**CEDAR KEY WATER AND SEWER DISTRICT**  
**INVITATION TO BID NO: 2025-01**  
**LIFT STATION REHABILITATION – PHASE II**  
**ADDENDUM NO. 5**

**January 27, 2026**

**CEDAR KEY**  
**SANITARY SEWER**  
**LIFT STATION**  
**REHABILITATION-PHASE II**

**STANDARD DETAIL  
FOR LIFT STATION 2  
IMPROVEMENTS**  
**M-903**

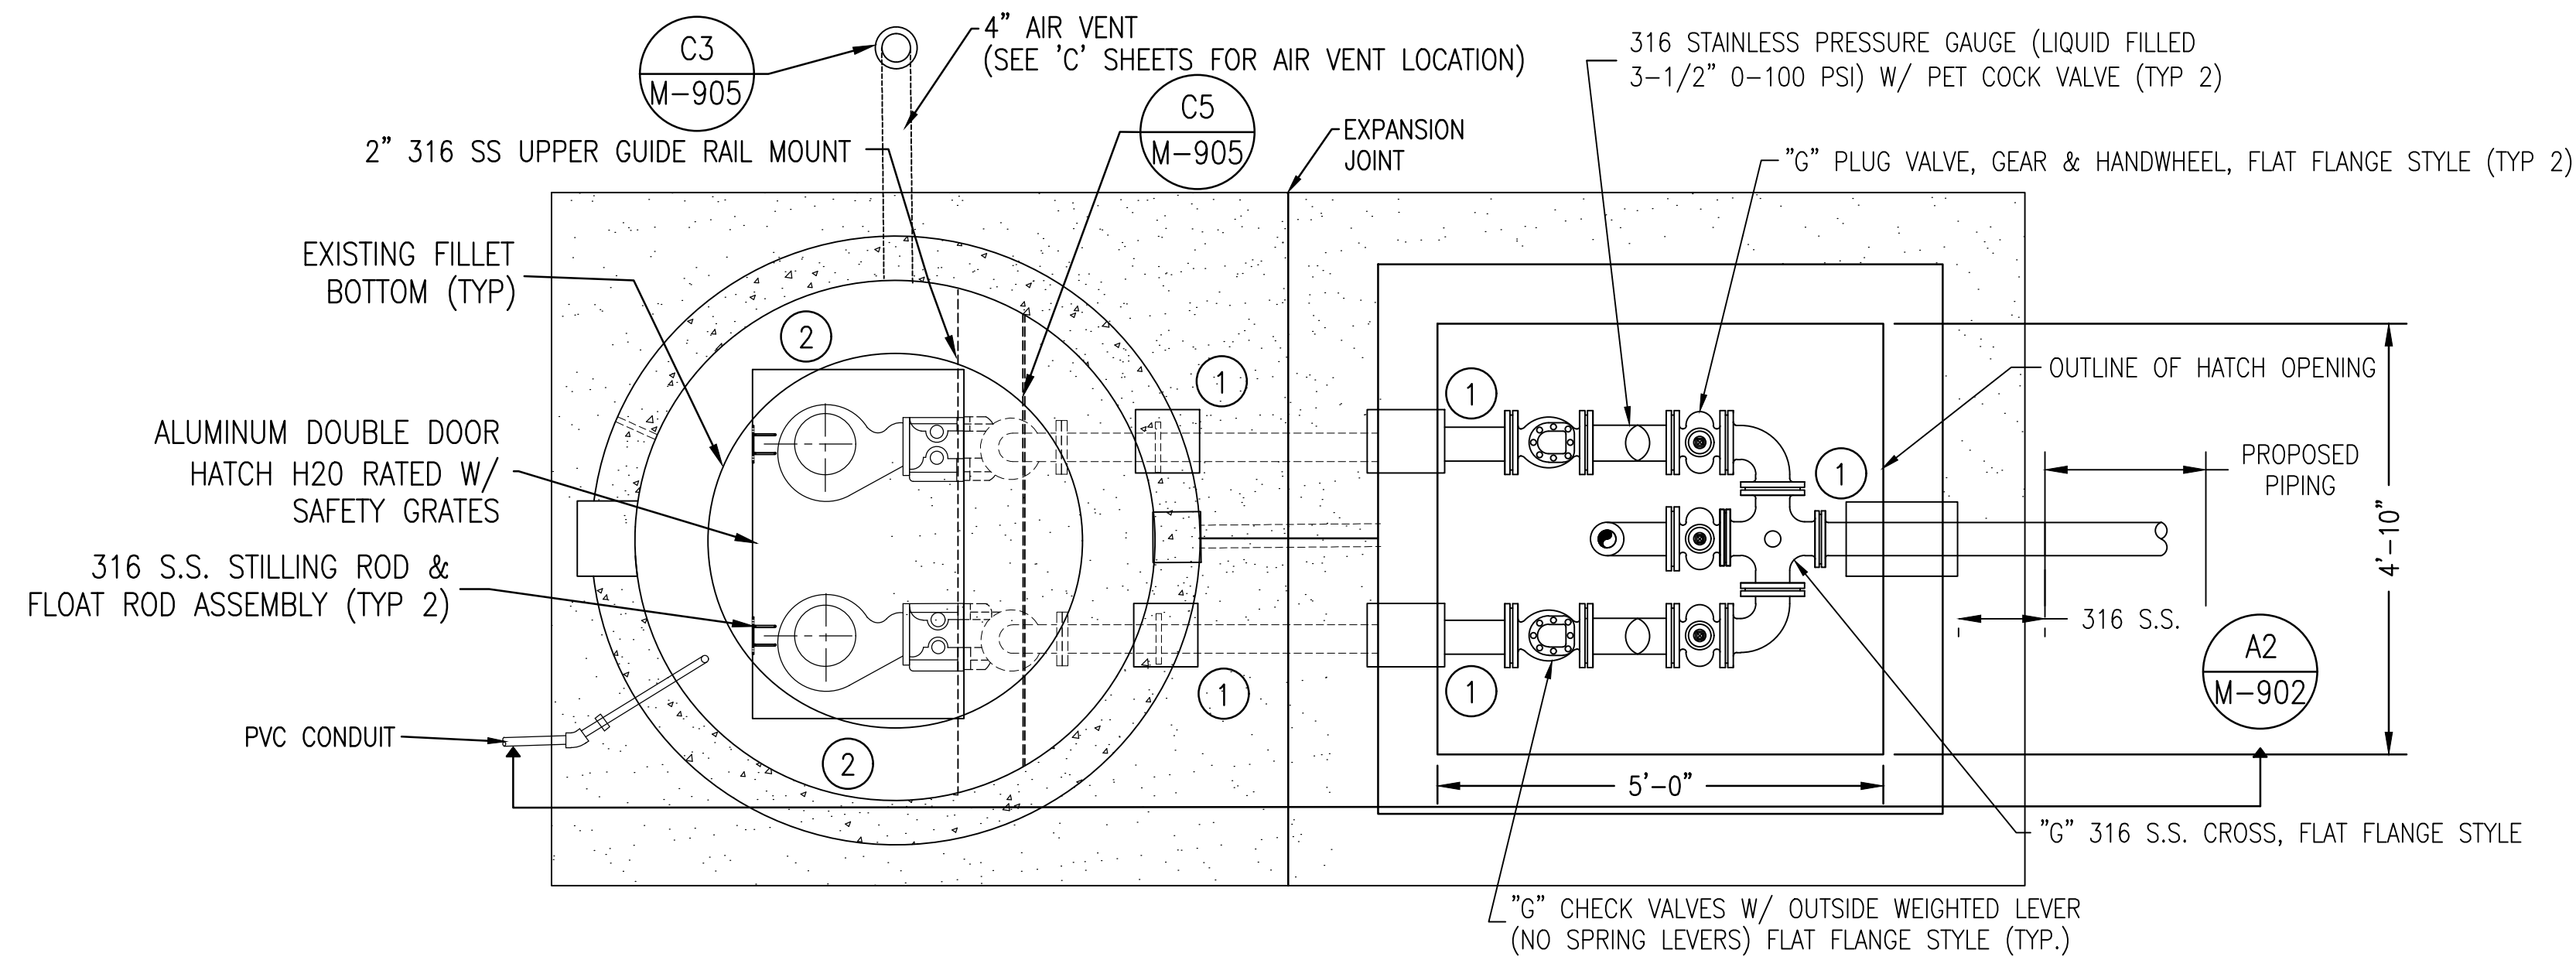
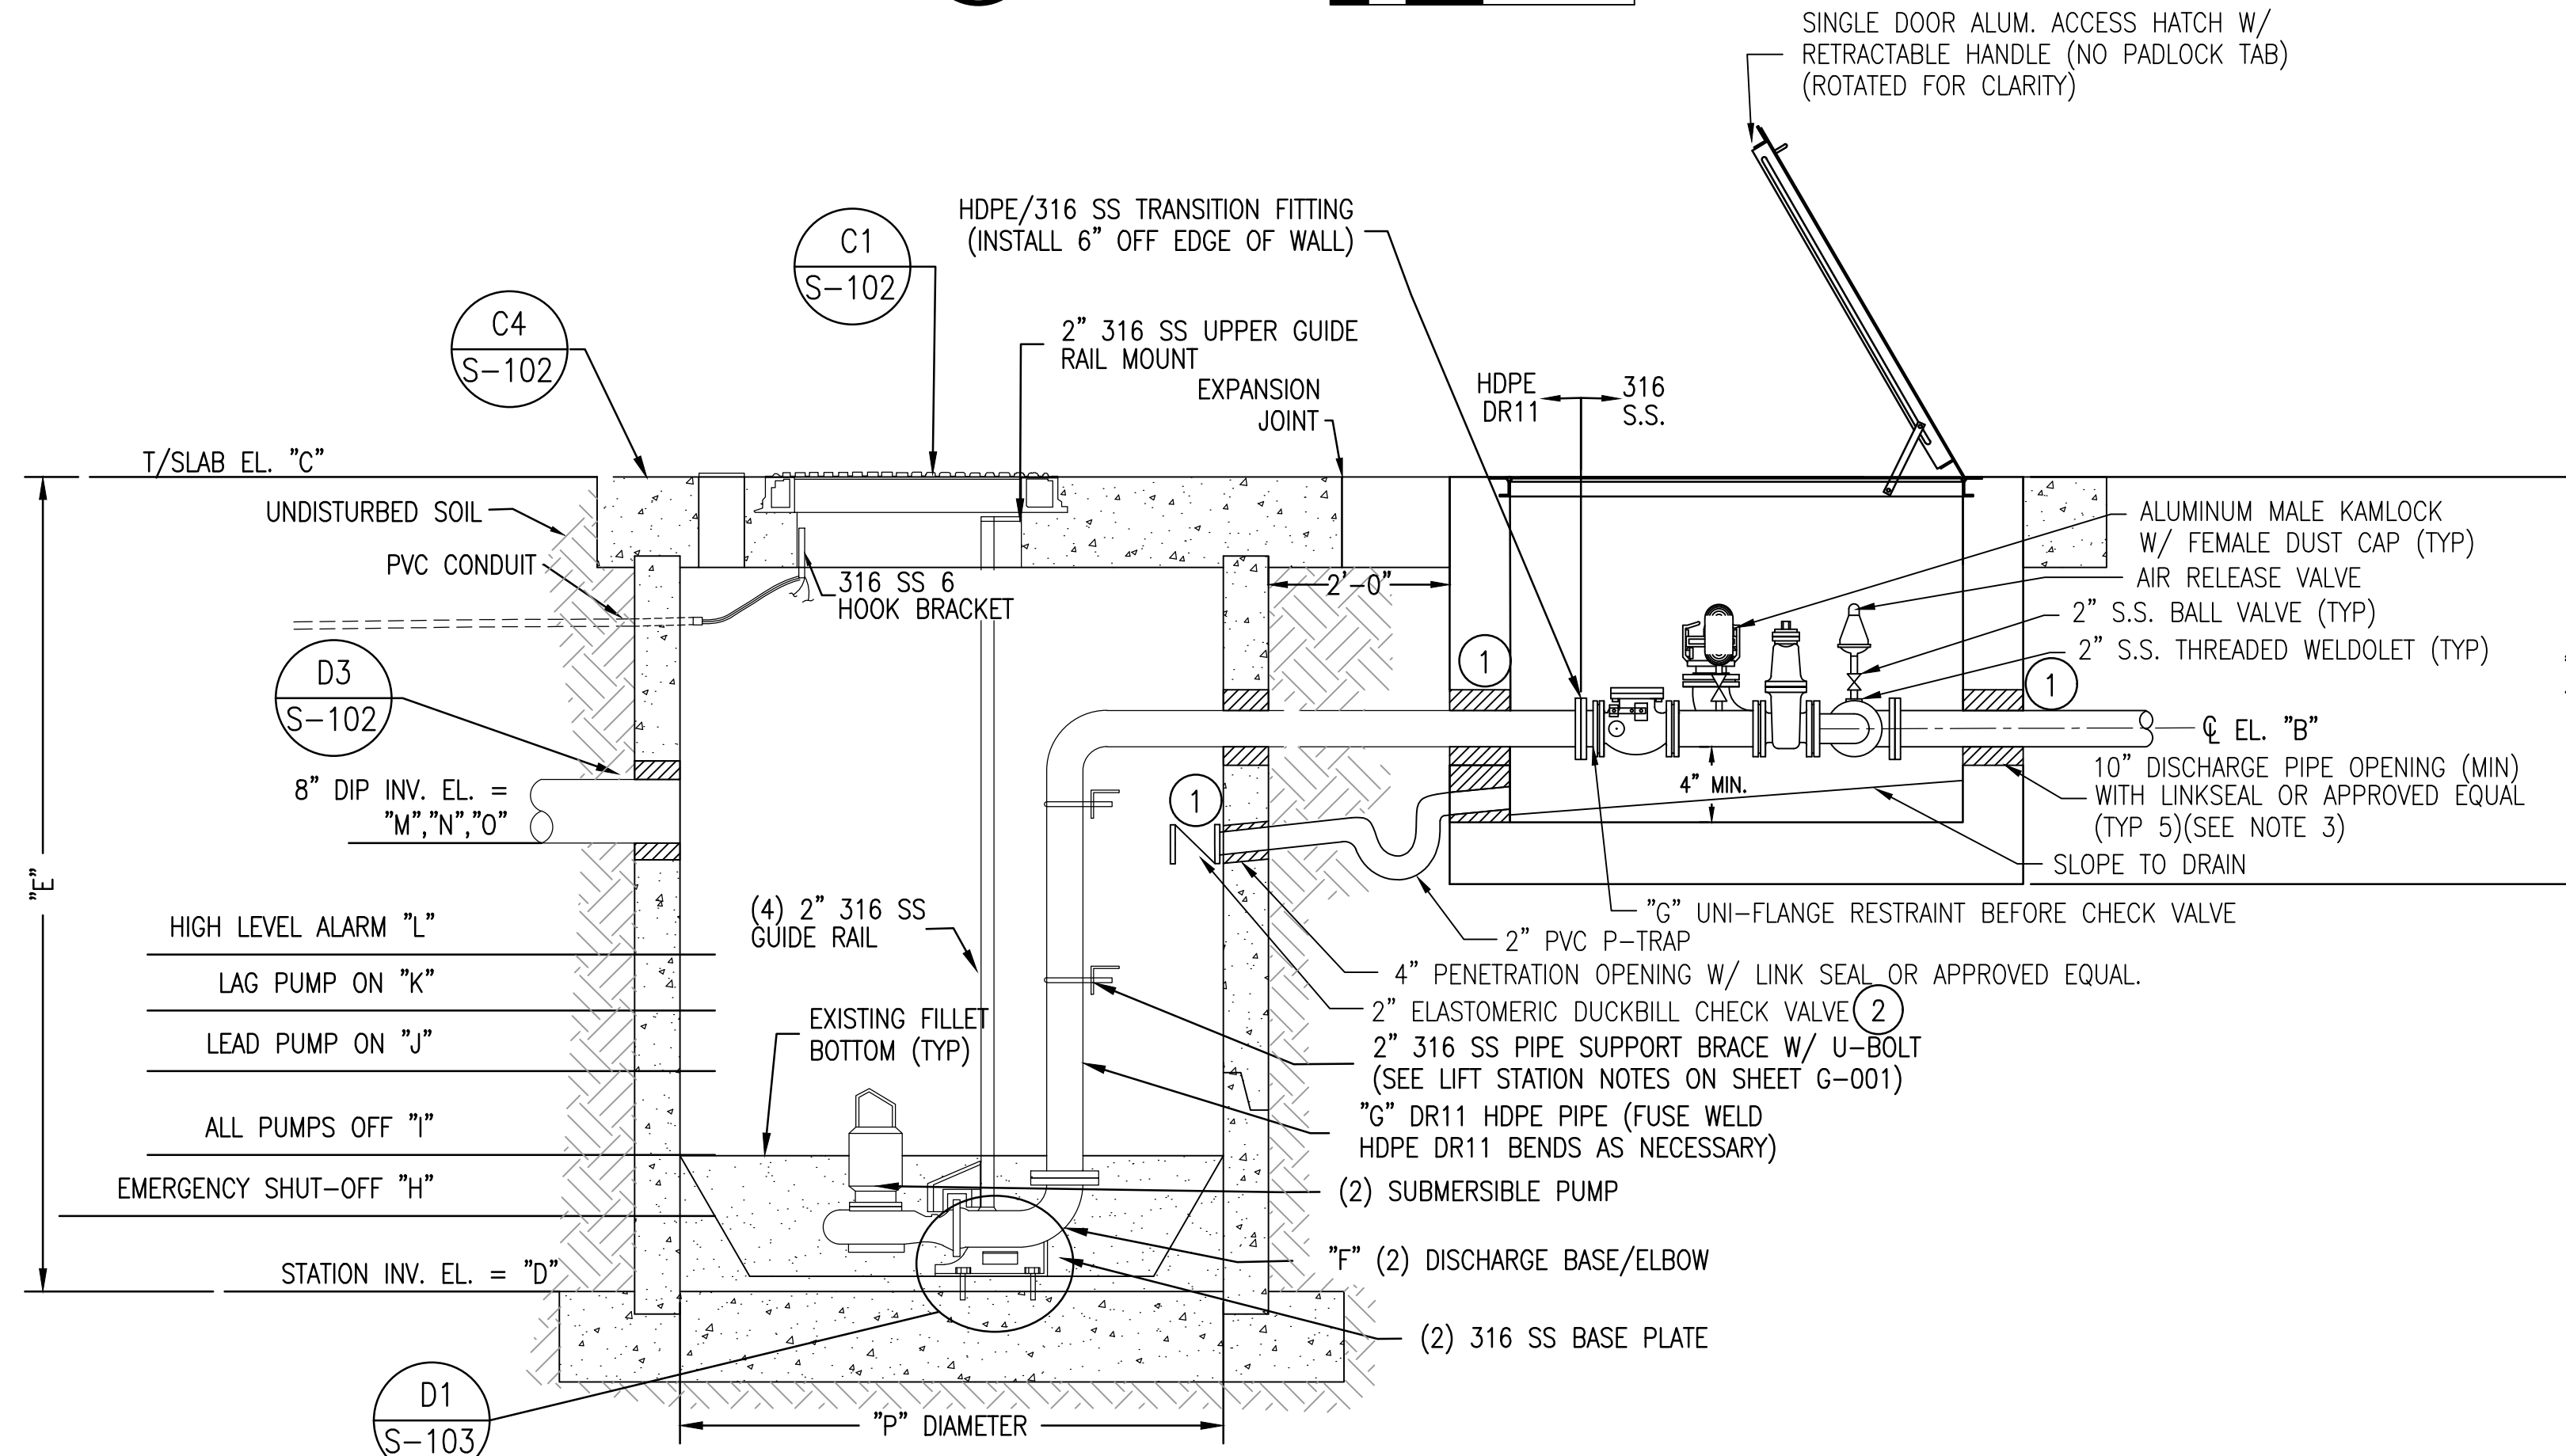
ITEM	DRAWING SHEET	CHANGE
1.	M-902 (REVISED SHEET)	The Pump Station Improvement Schedule was updated accordingly to reflect the adjusted operating conditions and float elevations.
2.	M-903 (REVISED SHEET)	The Pump Station Improvement Schedule was updated accordingly to reflect the adjusted operating conditions and float elevations.
4.	M-904 (REVISED SHEET)	The revise drawing sheets includes the updated discharge piping CL elevation and fillets required around the bottom of the fiberglass wet well basin per FDEP requirements.

DESCRIPTION	GPM	TDH	"A" (HP)	"B"	"C"	"D"	"E"	"F"	"G"	"H"	"I"	"J"	"K"	"L"	"M"	"N"	"O"	"P"	REMARKS
P S No. 2	154	19.2'	3.0	9.80	13.25	-2.15	±15'-5"	4"	4"	-0.43	0.78	2.03	3.03	3.30	± 4.61	± 4.33	-	5'-0"
